RE: SES Solar One Project  
 Applicant's Updated Project Map

**UPDATED PROJECT MAP  
SOLAR ONE PROJECT**

**Docket No. 08-AFC-13**

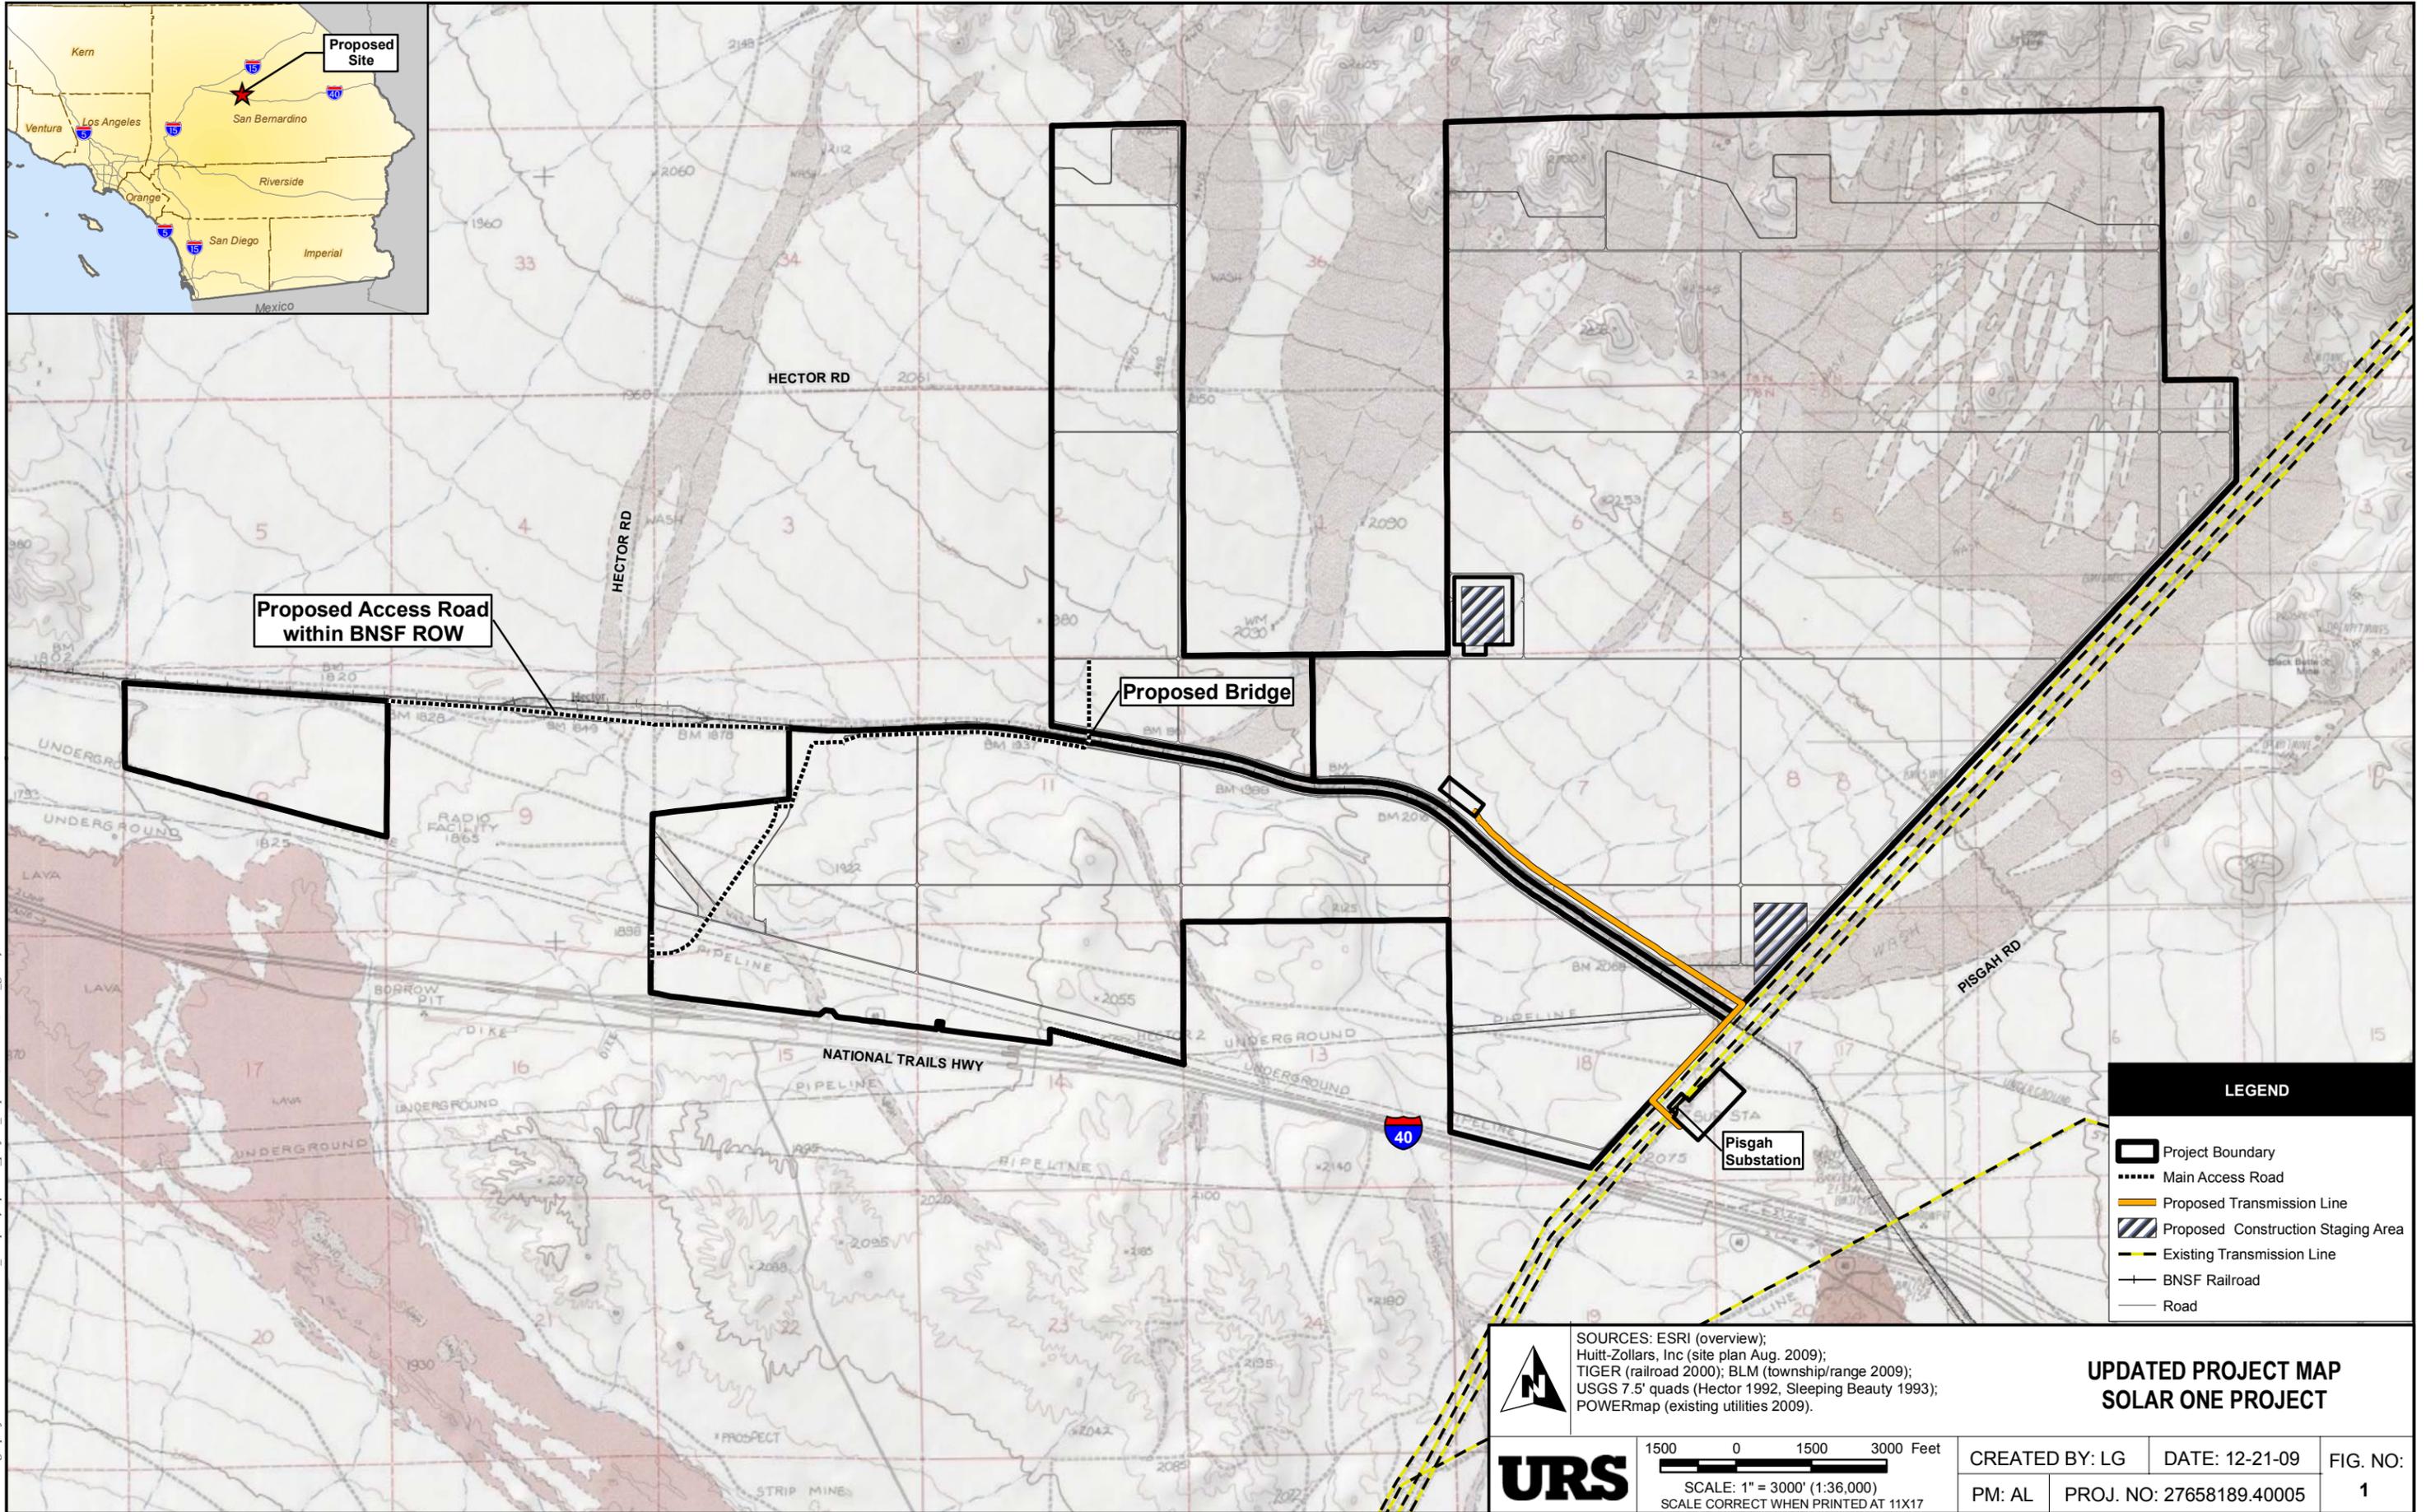
Tessera Solar, on behalf of the Applicant, submitted an updated Project Map for the Solar One Project on December 10, 2009. The updated map, however, had a small cartographic error; the Applicant is now submitting a revised package. Please note that Project acreage, as shown in the revised package, has not changed from the AFC filing, and is approximately 8,230 acres of public land Administered by the BLM. Private land is not included as part of the Project.

Tessera Solar, on behalf of the Applicant, hereby submits an updated Project Map for the Solar One Project (provided as Attachment 1). As demonstrated on the Attachment 1, an access road will be built along BNSF right-of-way, leading to the south-western most portion of the Project site. An authorization letter from BNSF is provided as Attachment 2. A summary table of Project modifications associated with this map and previously discussed during the discovery phase of the Project's environmental review is presented below.

PROJECT MODIFICATION	REASON FOR MODIFICATION
Project Boundary Update and inclusion of access road through BNSF Right-of-Way to access the south-western most portion of the site (discussed herein)	<ul style="list-style-type: none"> <li>• Needed to provide access to the Section which would otherwise be isolated by the sections which are not a part of the Project</li> </ul>
Move Solar One Main Access Road and Bridge so that it is within the Project site boundaries (discussed herein)	<ul style="list-style-type: none"> <li>• Reduce off-site impacts associated with the Project</li> </ul>
Project Phasing – through consultation with agencies and the public, the Applicant is working to develop a phasing plan that minimizes environmental impacts, where practical. The previously utilized Phase I and Phase II label refer solely to geographic locations (above and below the railroad, respectively) and may not be temporally-significant (discussed in the response to CEC and BLM Data Request 135)	<ul style="list-style-type: none"> <li>• Minimize environmental impacts, where practicable</li> </ul>
